National Grid

AMENDMENT REPORT

CUSC Amendment Proposal CAP001 Frequency Response Imbalance Payments

Amendment Ref	CAP001
Issue	2.0
Date of Issue	19 October 2001
Prepared by	National Grid

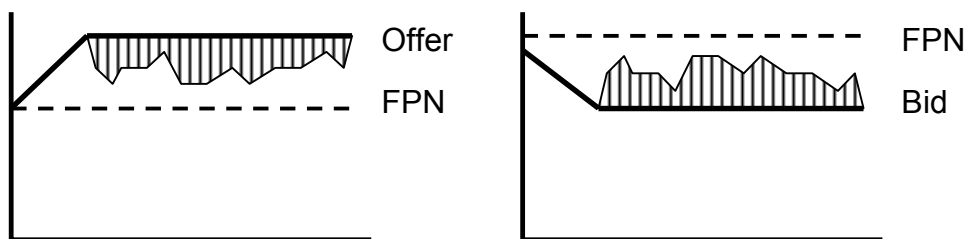
- 3.8 The mechanism introduced at NETA go-live uses values of Primary and High Frequency response capability contained within the response matrix. These values by definition reflect the power

delivered in response to a change in system frequency within 10 seconds from the time of the frequency deviation.

- 3.9 When a generator is selected for Primary and High Frequency response, it was concluded that use of the Primary and High values contained within the matrix, is a fair approximation of the response delivered on a continuing basis. However, when a generating unit is selected for Primary, Secondary and High, the low frequency response energy calculated can be considerably underestimated by using the Primary value alone.
- 3.10 It is therefore considered more appropriate to reflect the additional low frequency response power that is delivered after primary response time-scales i.e. 10 seconds. By taking the average of Primary and Secondary values it is possible to more closely approximate actual imbalance arising from the provision of frequency response.
